PIKE TOWNSHIP
MUNICIPAL AUTHORITY
DAM

NDS I. D. No. PA-00916
PENNDER I. D. No.17-111

PHASE I INSPECTION REPORT
NATIONAL DAM INSPECTION PROGRAM

GAI CONSULTANTS, INC.
570 BEATTY ROAD
MONROEVILLE, PENNSYLVANIA 15146
APRIL 1979

FIGURE 1 - PIKE TOWNSHIP MUNICIPAL AUTHORITY DAM
 GENERAL PLAN
 FIELD INSPECTION NOTES

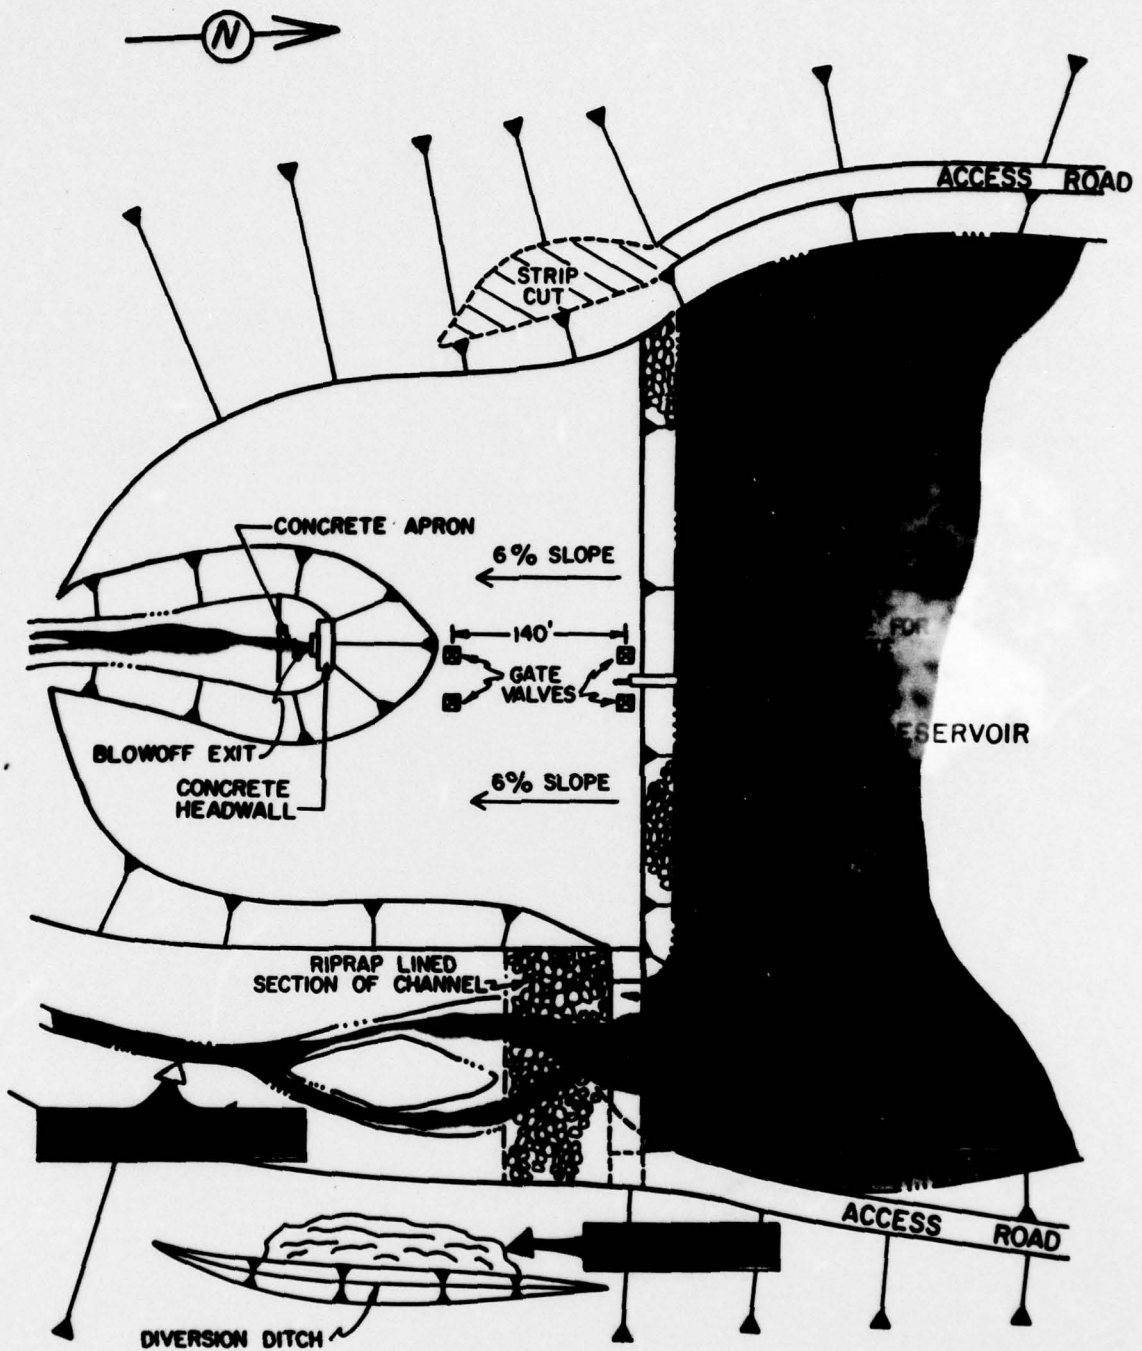
1. Spillway. A single structure has been provided for the facility which operates as both the service and emergency spillway. Visual inspection indicated that it is in poor condition having deep erosion gullies (8 feet deep) immediately downstream of the heavily riprapped segment (see Figures 1 and 3). Active sliding of the left channel wall is also evident and is possibly related to loss of toe support from spillway downcutting. The slide is shown in Photographs 7 and 8.

In addition, in order to restore the original spillway grade after serious erosion occurred in June 1977, an access road was built along the left bank of the reservoir and across the spillway control section. This has effectively reduced the spillway width by about 20 feet.

b. Appurtenant Structures. The open channel spillway system has been troublesome since completion. At the time of inspection, severe erosion was evident in the spillway channel and instability of the slope forming the left channel wall was observed (see Figure 1).

- a. Immediately remove the access road obstruction from the spillway.

b. Complete the current spillway evaluation and take appropriate remedial measures to ensure both the structural and hydraulic adequacy of the system.

c. Monitor the movement of the slide on the left abutment. If movement becomes excessive, remedial measures are warranted for protection of the spillway channel.
